SITE INSPECTION REPORT FOR 42 MLD Sajari STP

SAJARI STP

**Date:
10.05.2022**

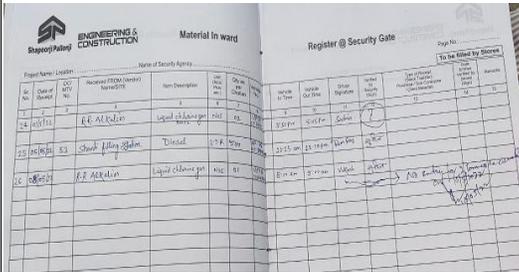
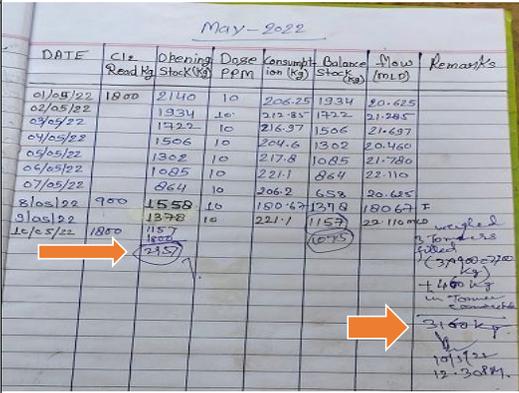
| 1 | Raw Sewage Pump-01 | Non-Operational | | 1) Need to be rectified at the earliest. 2) Discharge line pressure gauge calibration/ test certificate needs to be submitted. | | 1) 10.01.2022 2) 21.09.2021 | 15.01.2022 / New date 15.05.2022 | LONG PENDING |
| 3 | Raw Sewage Pump-03 | Operational Pressure gauge was found old one and is showing high pressure with respect to others. |  | Discharge line pressure gauge needs to be replaced and calibration / test certificate needs to be submitted. | | 31.07.2021 | | LONG PENDING |
| 4 | Raw Sewage Pump-04 | Non Operational After almost 2 months of non-operational since 31.12.2021, it was made operational on 07.03.2022, again on 10.05.2022 it become non operational. | | 1) Needs to be rectified. 2) Discharge line pressure gauge calibration/ test certificate needs to be submitted. | | 1) 10.05.2022 2) 31.07.2021 | 15.01.2022 | |
| 5 | Raw Sewage Pump-05 | Operational | | In the meeting dated 11.04.2022, ED (T) NMCG directed KRMPL to rectify the issue and submit the calibration certificate of all pressure gauges at the earliest. | | 27-10-2021 | 15.01.2022 | LONG PENDING Needs to submit the calibration/ test reports of pressure gauge. |

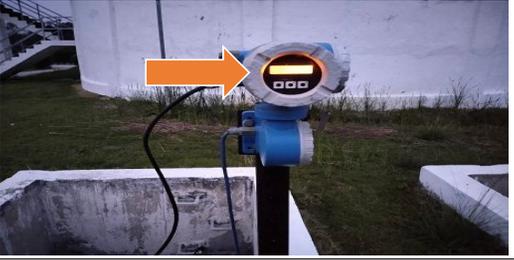
| 9 | Grit Disposal | When STC team reached site, no trolley was found below grit & conveyor chutes. |  | <ol style="list-style-type: none"> 1) Provide trolley below conveyor and grit chute. 2) Remove the grit on regular basis. 3) Apart from this, make sure that spare trolley must be provided in case of shifting/ removing grit. | | | 11.01.2022 | | Pending |
